Project Name:	Municipal Fleet Storage Garage
Addendum Number:	3
Project ID:	2026-RFP-009

Addendum 3 is hereby issued to amend the *2026-RFP-009 Municipal Fleet Storage Garage*. The changes outlined in this addendum shall take precedence over the original document.

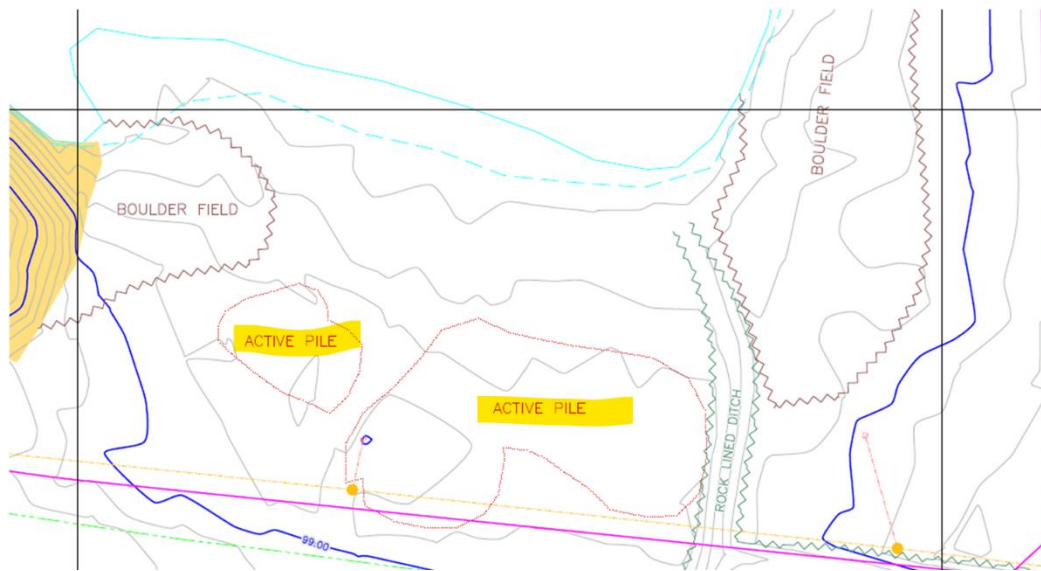
The topographical plan issued as part of the RFP references an "active pile" (See below). Could you please clarify what this specifically refers to? Additionally, please confirm whether the Owner will be responsible for relocating or removing any active piles, if required for construction activities.

The “active pile” identified on the topographical plan refers to a temporary aggregate/material stockpile that was used for a previous City project. The stockpile has since been removed from the site.
